**Flat A, 124 Greencroft Gardens, London, NW6 3PJ**

**Appeal by Iain Wilson**

## **DECISION**

Erection of single storey rear extension with green roof, following demolition of existing rear extension.

Image 1

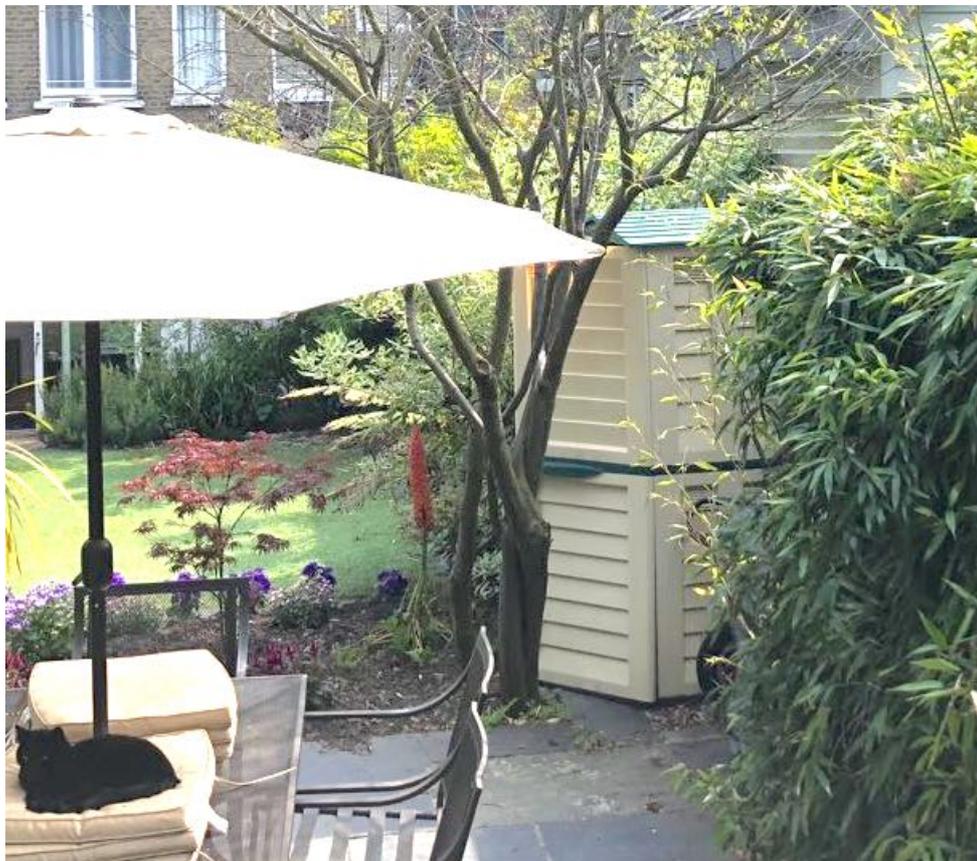
7. Photograph Two:  
The representation of the raised boundary wall is not correct:
  - a. It does not extend so far beyond No 126 Garden Studio in length.

- b. The height indicated on the photograph is a significant misrepresentation. The brick coursing of the existing wall is visible in photograph and this demonstrated that the "proposed new wall" as drawn does not follow the perspective of the photograph. As drawn the wall appears to slope higher towards the rear, giving the impression that the wall would be more imposing than proposed. The top of the proposed wall is horizontal and 8 brick courses higher than the existing wall. Please refer to Image 1 and 2 below.

It is not clear where these dimensions are measured from. Crucially, we note that the proposed raised height of the party wall is 8 brick courses as demonstrated by Image 1 and Image 2 below. This is approximately 0.6m, not 1.2m as stated in the objection letter.
